CITY OF LAS VEGAS DETENTION CENTER

2ND FLOOR PLAN
 SCALE: 1/8" = 1'-0"

PROJECT: CLV DETENTION CENTER BUILDING 1 & 2 2ND FLOOR
TYPE OF SYSTEM: FIRE ALARM
DRAWN BY: S.W.W.
CHECKED BY:
DATE: 07/13/2009
SCALE: 1/8"=1'-0"
JOB #: 2866
SHEET FA-02

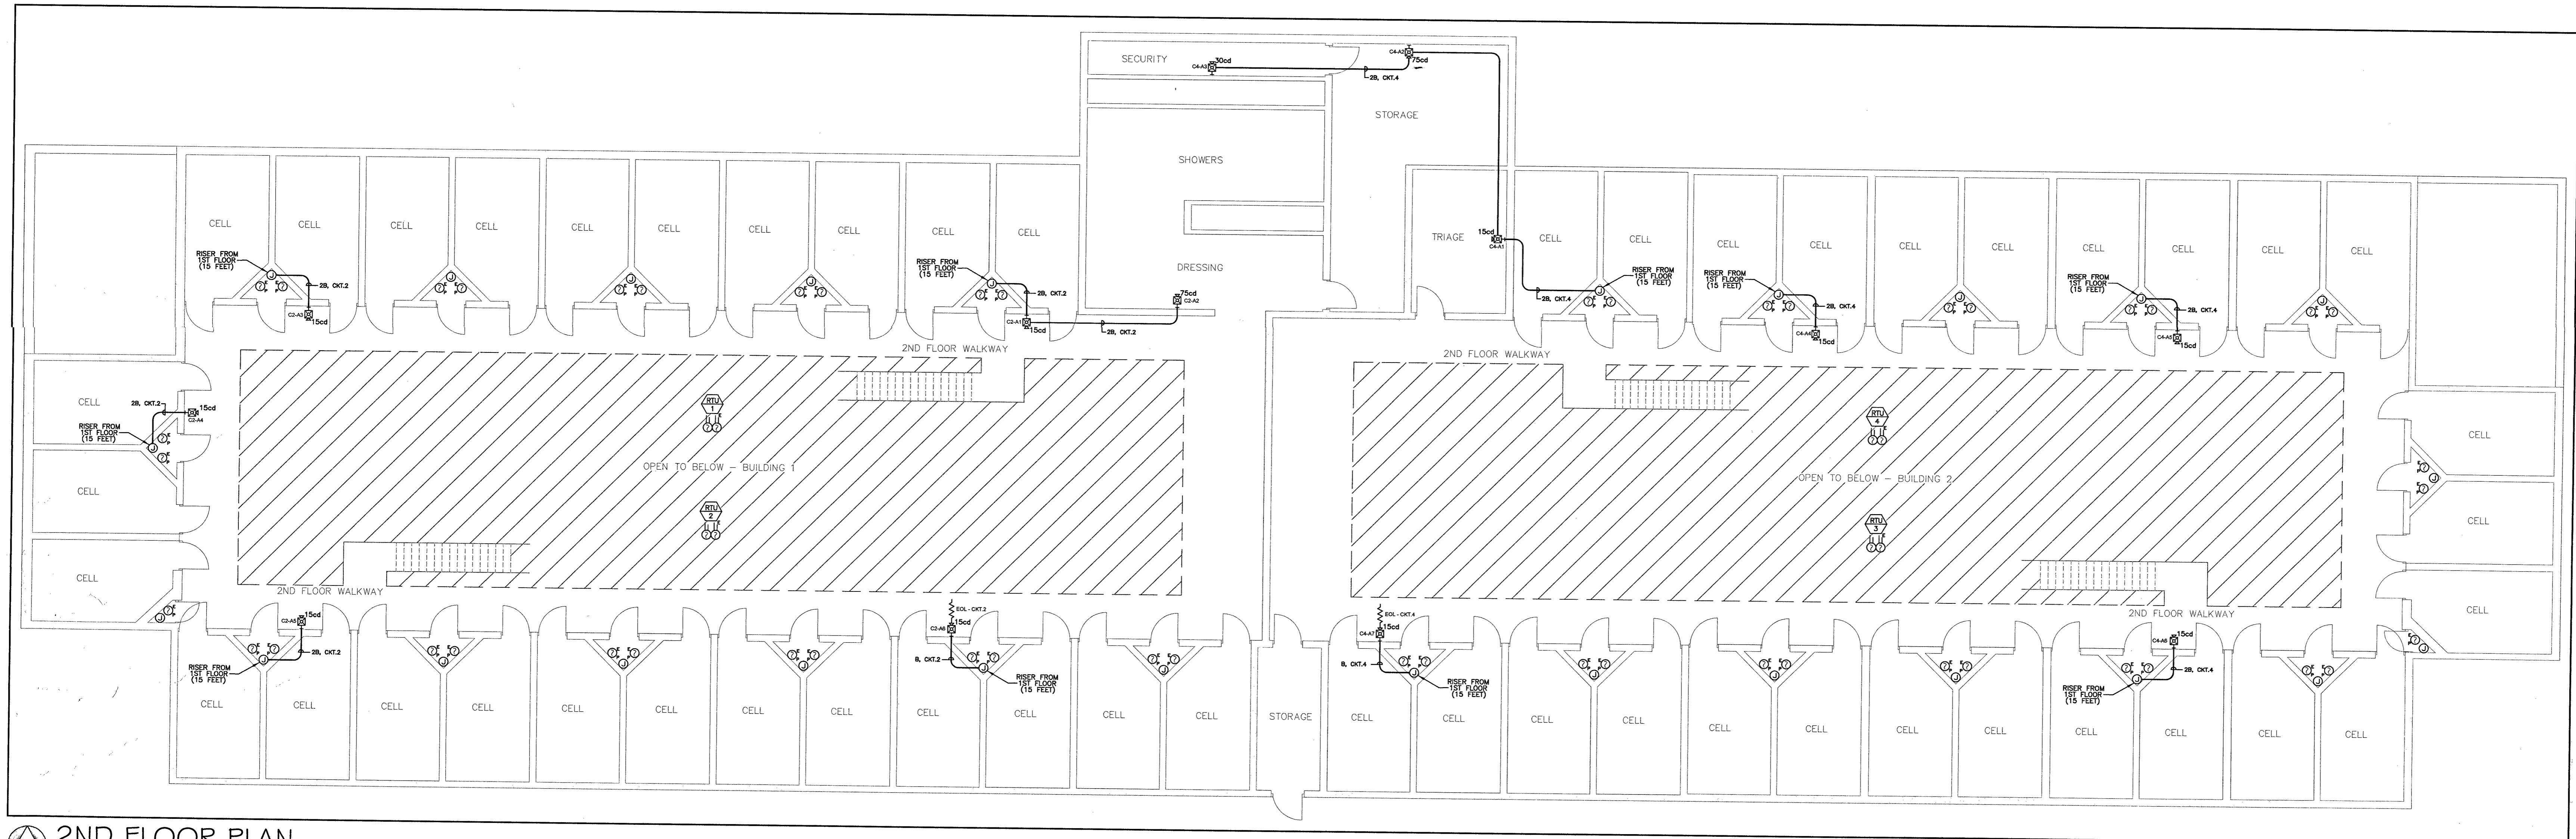
For the mechanical & electrical rooms, audible alarm signals shall either have a sound level at least 15 dB above the average ambient sound level per NFPA 72 '02 § 7.4.2.1, or 80 dB as required by CLV Ordinance #5667, whichever is higher. If this sound level is not achieved, then add strobe device(s) as allowed by NFPA 72 '02 § 7.4.2.2.

The visible notification appliances must be of a type, size, intensity, and number so that the operating effect of the appliance is seen by the intended viewers regardless of the viewer's orientation (including the areas behind curtains) per [NFPA 72 § 7.4.2.1].
